Field Safety Notice

Affected Products: Shimadzu CVS system : Trinias

Figure 1

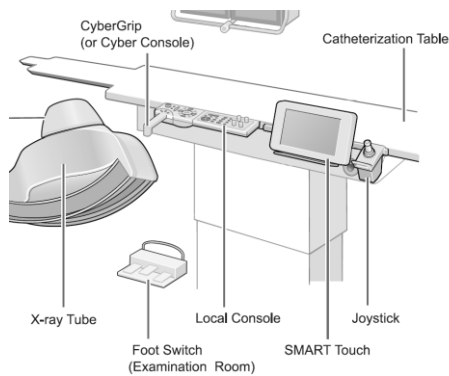
If SMART Touch is installed as shown in Figure 1, press the "X-Ray OFF" button shown in Figure 2 to stop X-ray output.
